INTERSTATE 90 EXIT 46

**INTERCHANGE MODIFICATION JUSTIFICATION REPORT
(IMJR)**

**METHODS AND ASSUMPTIONS
DOCUMENT**

Methods and Assumptions Meeting

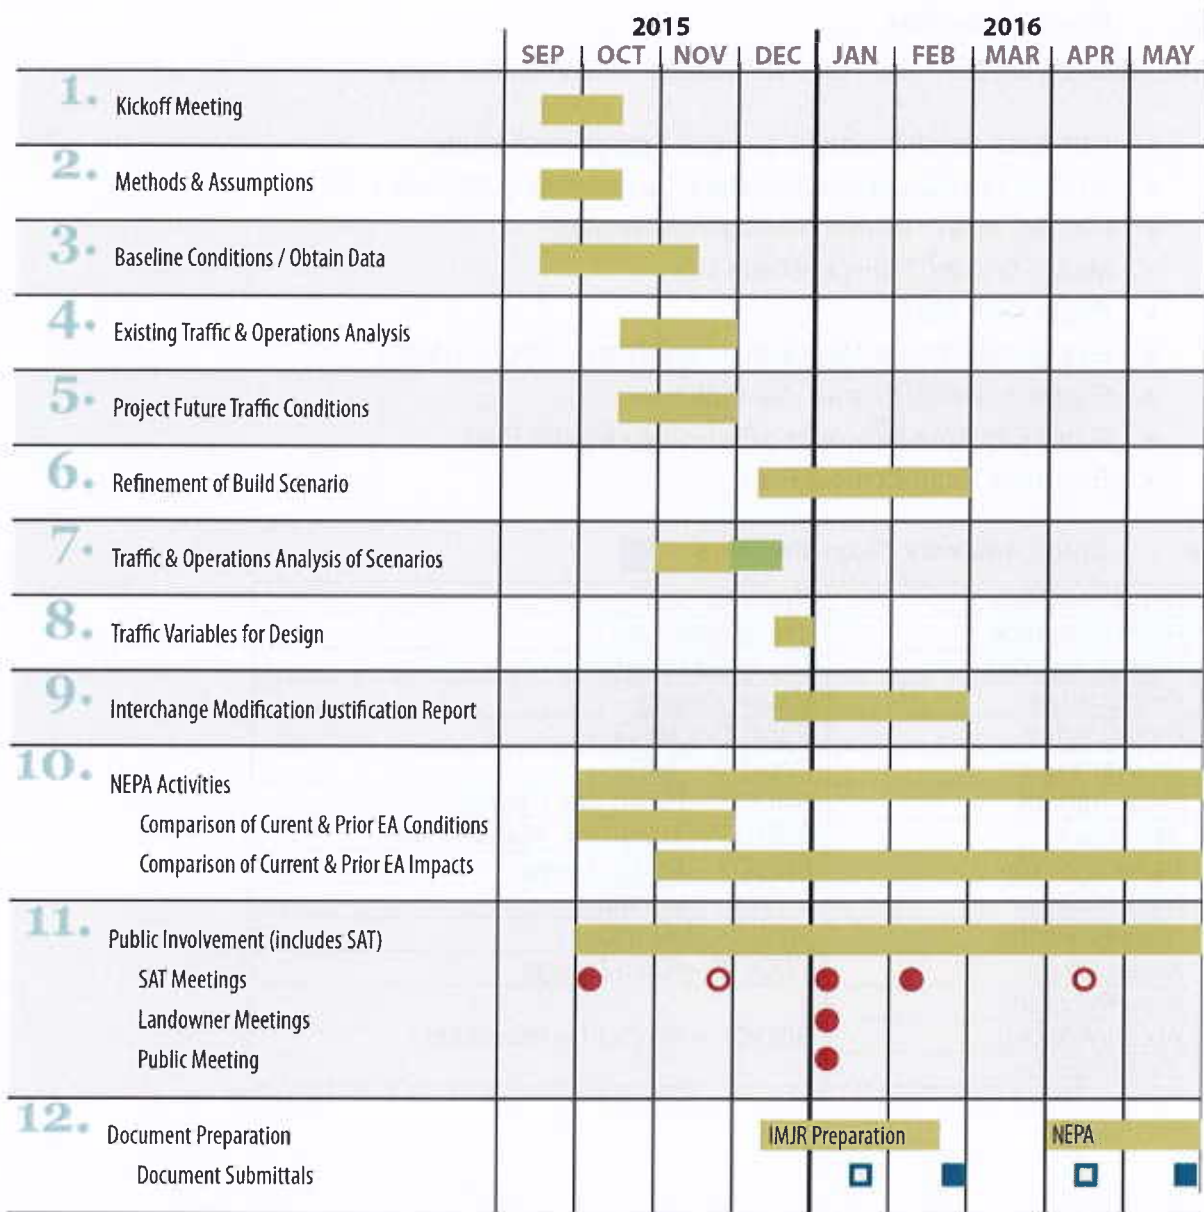
- **Section 3. Introduction and Project Description**
 - The following edits were suggested:
 - Consider revising the description of the location of the interchange to more accurately describe its proximity to the boundaries of the cities of Piedmont and Summerset.

Interstate 90 (I-90) Exit 46 is configured as a diamond interchange in Meade County serving Elk Creek Road, which lies adjacent to the cities of Piedmont and Summerset. In addition to Elk Creek Road and I-90, affected facilities include Sturgis Road, Spring Valley Road, Deerview Road (Exit 44), and Stage Stop Road (Exit 48).

Figure 2. Traffic Count Locations

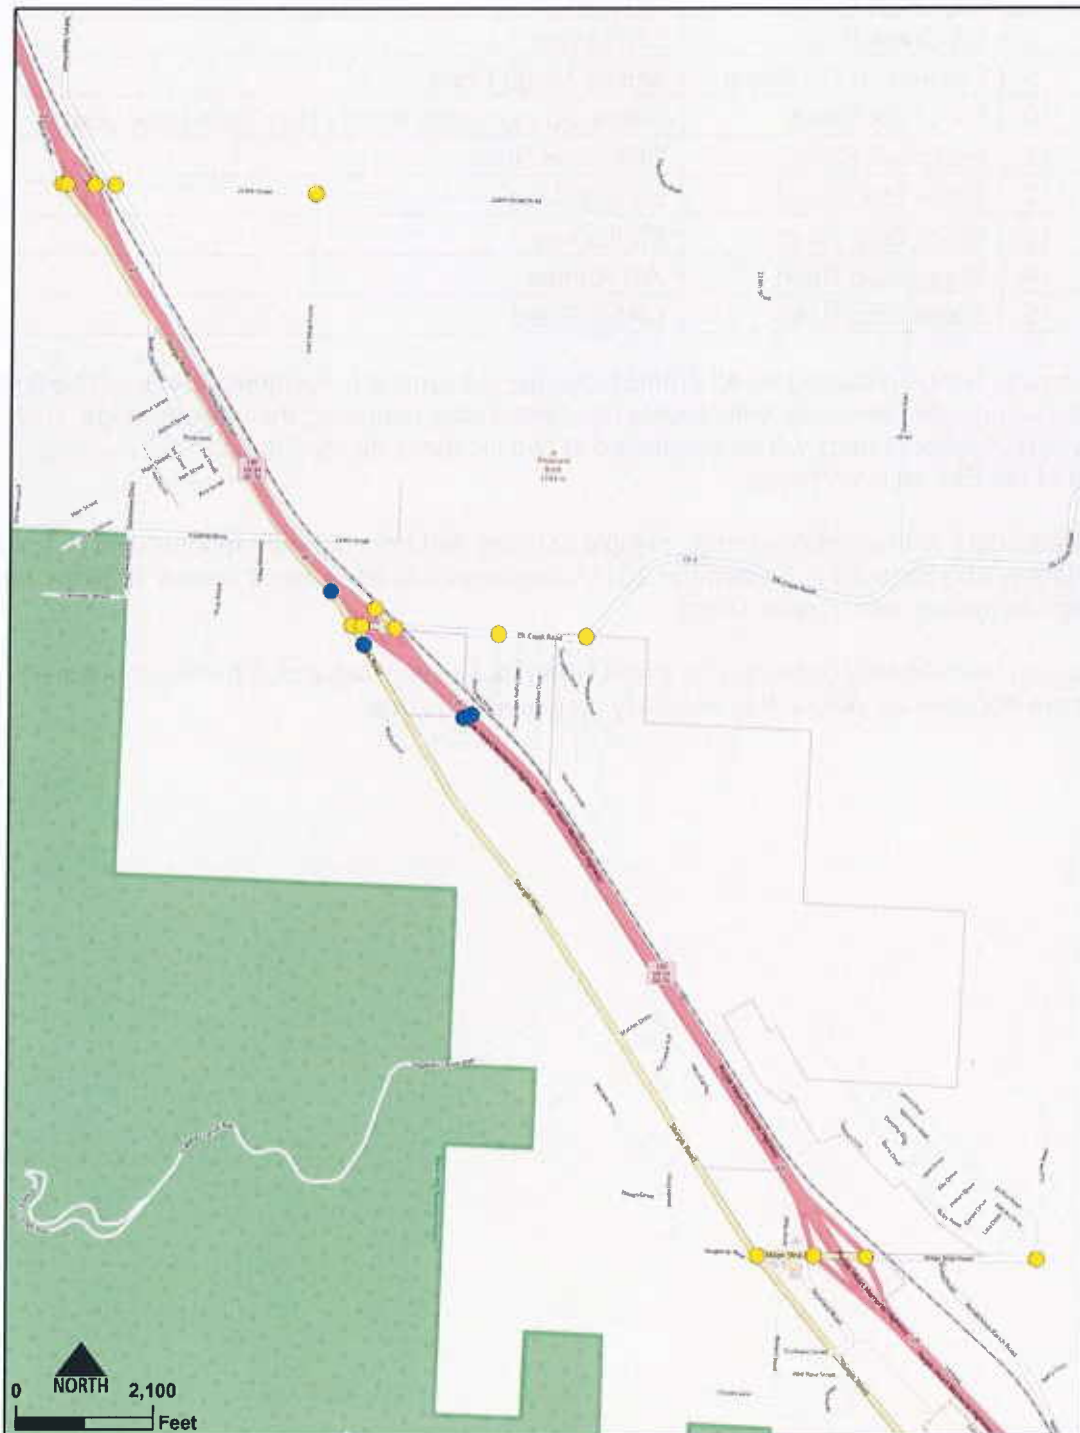
- It was agreed the peak hour intersection turning movement counts would be conducted between 6:30 AM-8:30 AM and 4:00-6:00 PM.
 - A map showing the locations where traffic count data was collected will be added to the IMJR report.

- It was requested that SDDOT set tubes on Interstate 90 to the north of Exit 46.
- **Section 7. Traffic Operations Analysis**
 - It was requested that the values planned to be used for analysis variables, such as PHF, truck percentage, saturation flow rate, etc. be listed or methodology planned to be used to calculate them be defined.

Traffic counts will be collected by All Traffic Data, Inc. All turning movement counts will be field collected using video cameras, with counts conducted after compiling the video footage. Daily vehicle classification counts will be conducted at two locations along Sturgis Road and along I-90 east of the Exit 46 interchange.

The map on the following page depicts traffic count locations. Intersection turning movement counts are depicted as yellow dots and daily counts as blue dots.
